Product Change Notification

Change Notification #: 116072 - 00

Change Title: Intel® Omni-Path Director Class Switch 100 Series 6 Slot Base 1MM 100SWD06B1N,
Intel® Omni-Path Director Class Switch 100 Series 24 Slot Base 1MM 100SWD24B1N,
Intel® Omni-Path Director Switch Management Module 100 Series 100SWDMGTSH,
Intel® Omni-Path Director Class Switch 100 Series 6 Slot FRU Chassis 100SWD06CHS,
Intel® Omni-Path Director Class Switch 100 Series 24 Slot FRU Chassis 100SWD24CHS
PCN 116072-00, Product Design, Label, Firmware Updates, Regulatory Label Updates, Chassis Bracket and Gasket Updates

Date of Publication: February 13, 2018

Figure 3. 100SWD24 Regulatory Label, Before

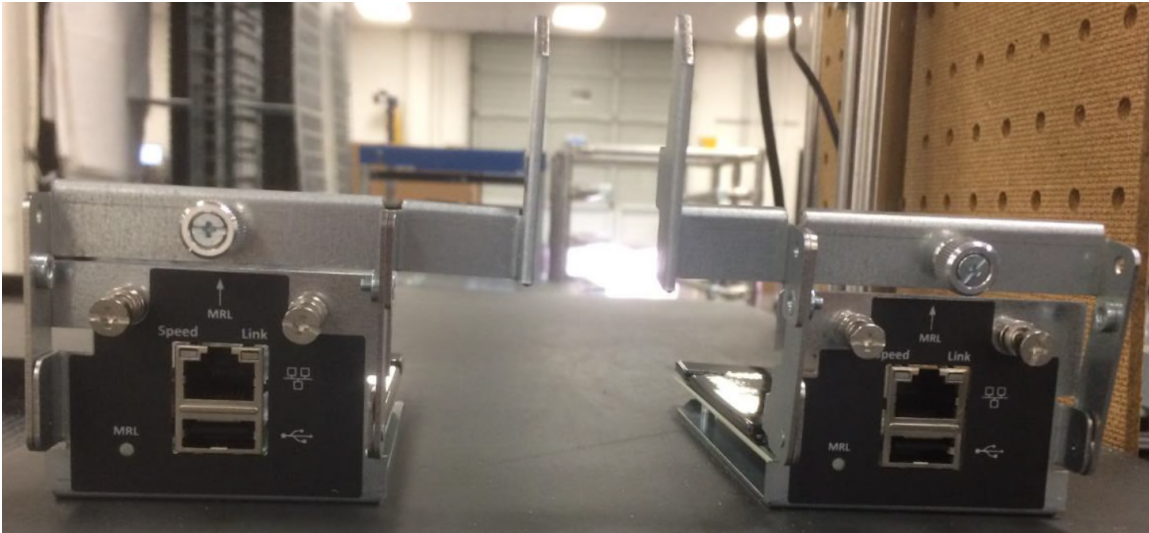
Change 2: An updated regulatory certification was acquired for BSMI (Taiwan) showing compliance with the new Taiwan RoHS requirement. In addition, compliance with the new Ukrainian RoHS requirement was documented. The right side regulatory label shall be updated to reflect compliance with these new RoHS requirements, as well as the new ANATEL certification to enable shipments to Brazil.

The regulatory label updates for 100SWD24B1N and 100SWD24CHS are shown in **Figure 3** and **Error! Reference source not found.** below.
